VILLAGE OF MONROE
Special Meeting Minutes
December 15, 2025

Site Plan Review – Proposed 2 Story Office Building

Village of Monroe Planning Board Review

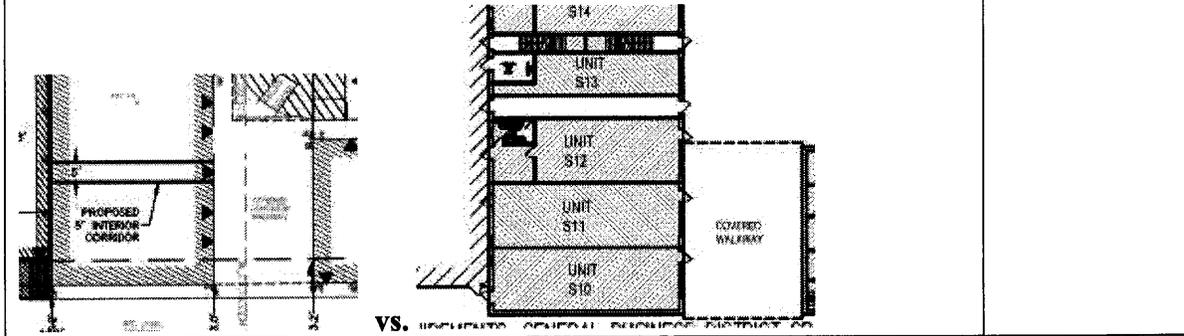
11. Page G-22, 5.11 City Collector to be amended to Receiver of Taxes.	Comment Satisfied
12. Revised floor plans have been submitted. However the unit designations have been removed and it difficult to identify whether requested changes have been made.

13. Site plan and subdivision layout are different with respect to the five foot corridor.

Diagram as shown on site plan:

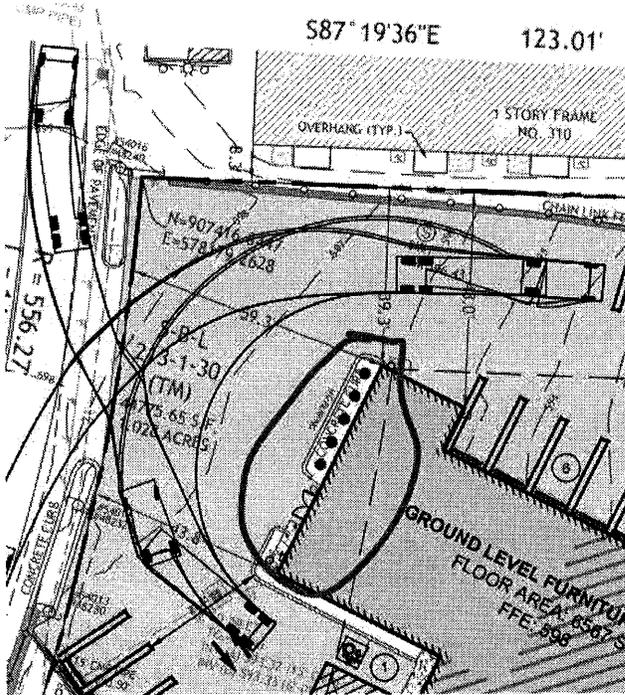
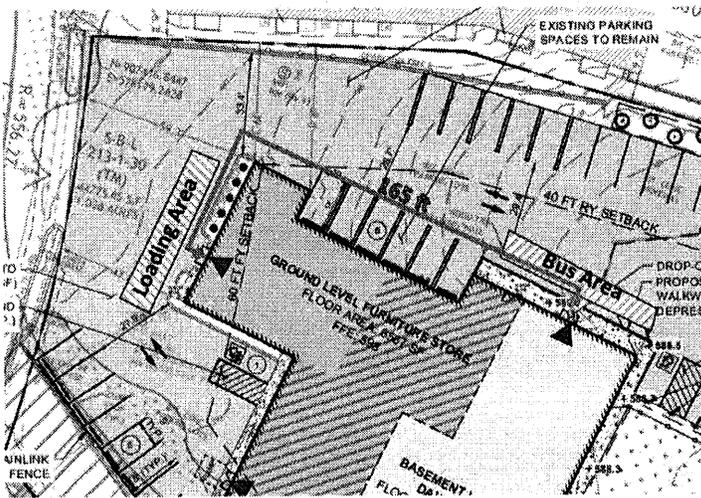
Diagram as shown on memorandum of Creighton Manning dated June 25, 2025
